Proposal for amendments regarding WP.29/2022/59

Modifications to the existing text of UN-Regulation No. 157 are in **bold** for new or ~~strikethrough~~ for deleted characters.

Model A

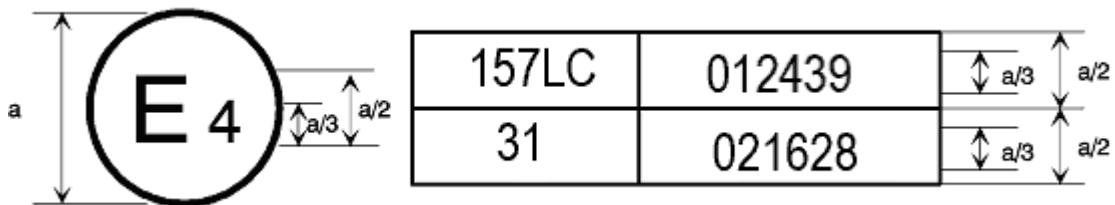
The above approval mark affixed to a vehicle shows that the vehicle type concerned has, with regard to ALKS, been approved in the Netherlands (E 4) pursuant to UN Regulation No. 157 under approval No. **002439 012439 and is capable of a lane change procedure**. The approval number indicates that the approval was granted in accordance with the requirements of UN Regulation No. 157 **in its original version with the 01 series of amendments incorporated**.
